AMENDMENTS TO THE DRAWINGS

REMARKS

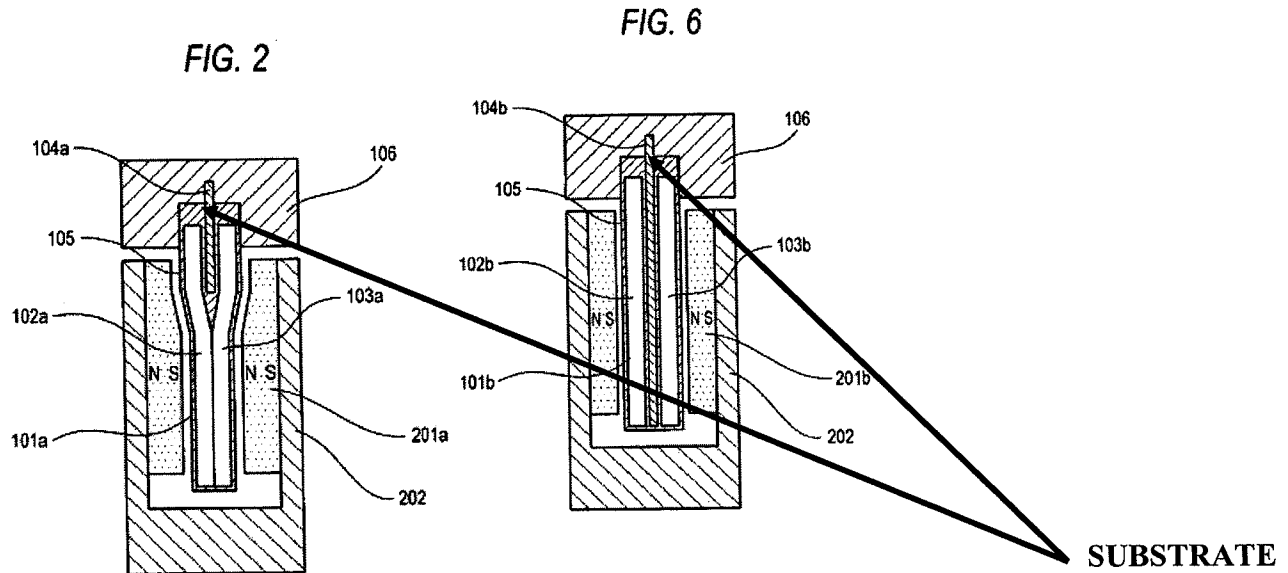
Drawings has been objected to because of various informalities.

The Examiner has objected to the Drawings because of various informalities. We propose submitting revised drawings with Figs. 5 & 6 duly marked "Prior Art" to overcome the noted objections.

The attached sheets of drawings include changes to Fig 5 and Fig. 6. The sheets, which include Fig 5 and Fig. 6, replaces sheet the original including Fig 5 and Fig. 6.

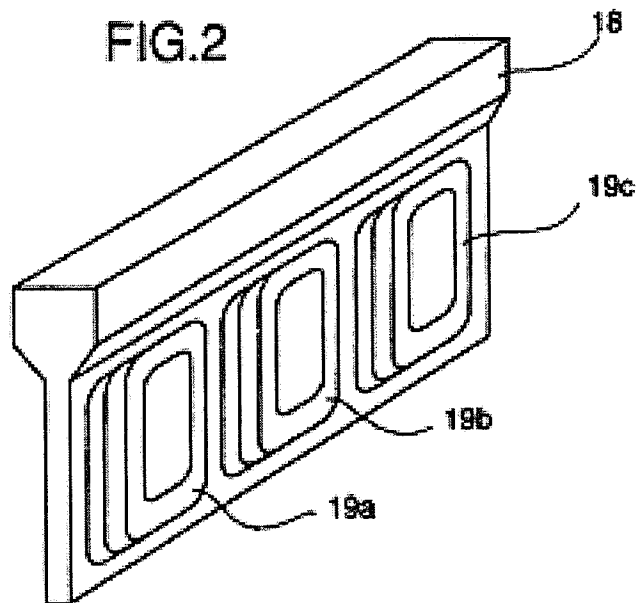
Cross section of the linear motor according to the present invention (as recited in amended claim 1), as well as the admitted prior art of Fig. 6 of the present Specification are reproduced below to illustrate the differences therein.

For example, in the admitted prior art of Fig.6, the substrate 104b is positioned all along the longitudinal section in between the armature coils 102b and 103b. On the other hand, in the present invention the substrate 104a is positioned only in the gap that is formed between the branching ends of the armature coils 102a and 103a.
